Urban Design Brief - 150 Dun Skipper Drive Residential

Prepared by Novatech, January 20, 2025

Response to Urban Design Comments on Preliminary Design (provided October 21, 2024)

Design Research - Alternative Site Plan Option

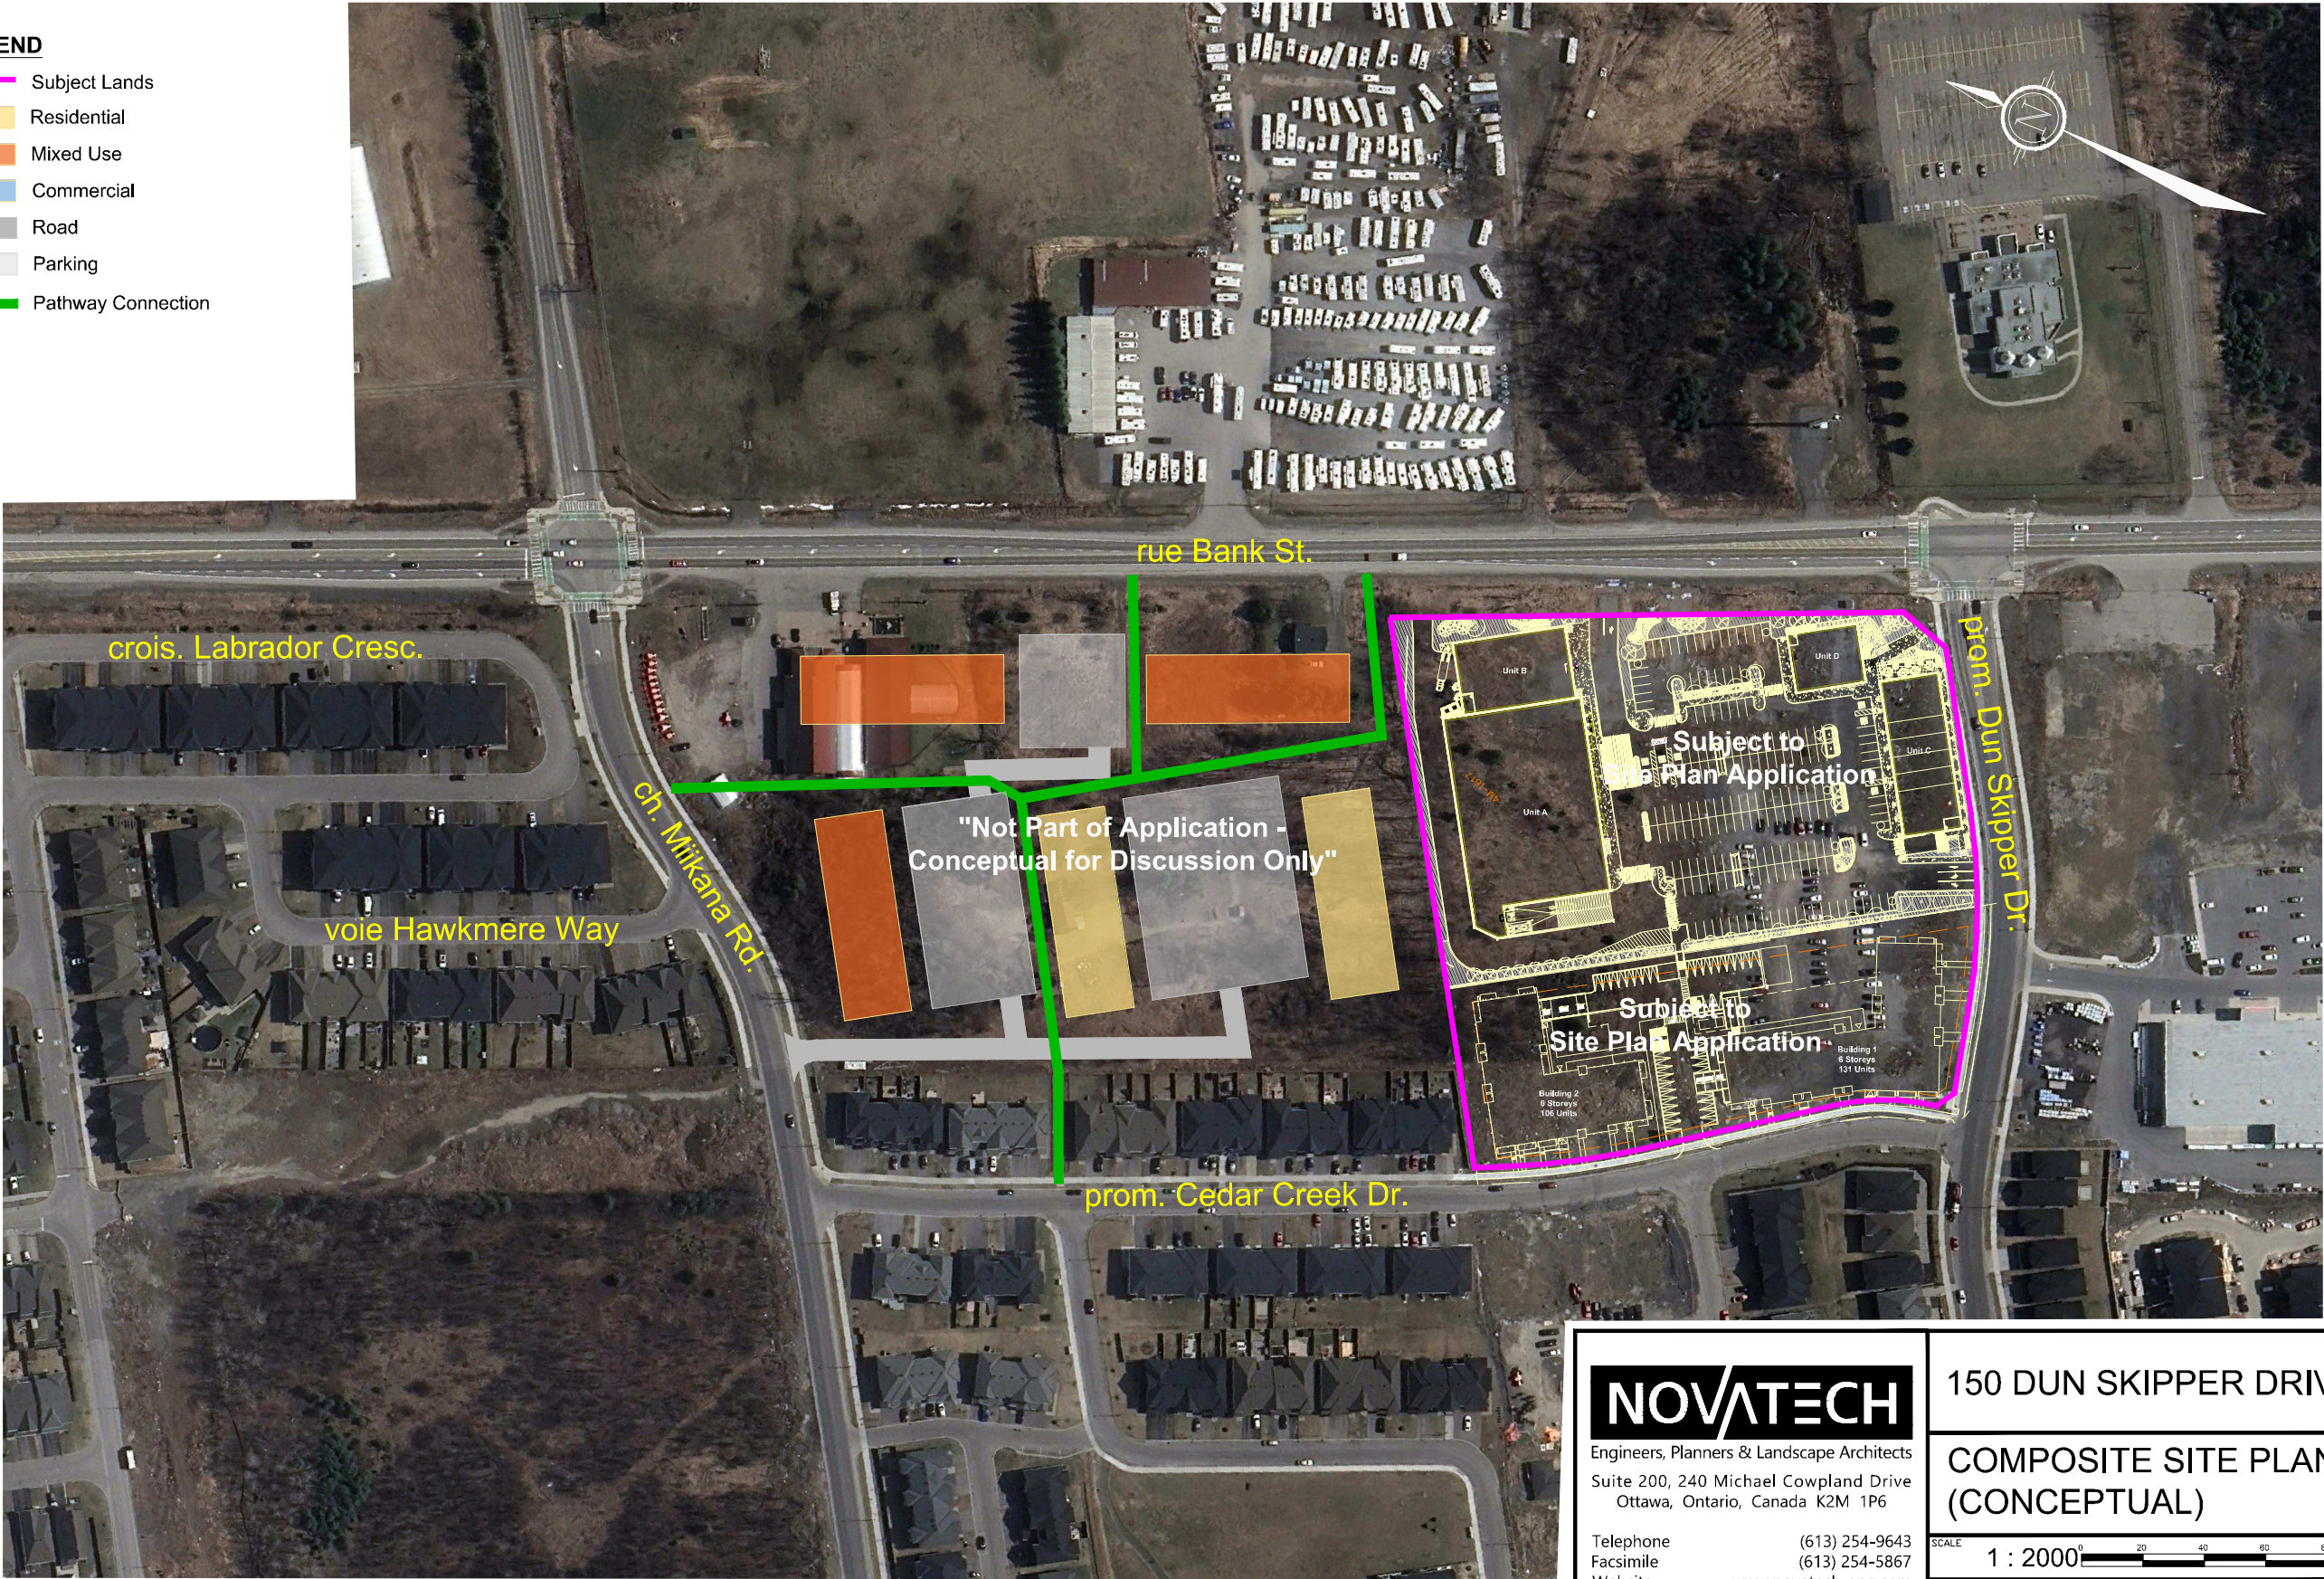
17.Consider providing public access through the site from Pingwi Place to Bank, as this will be a desire line for residents. Please ensure that direct safe, pedestrian connections are provided.

Response: This will be provided. It is shown on the revised Site Plan.

The Site Plan option below dated November 15, 2024 did not include a pedestrian connection to the east.
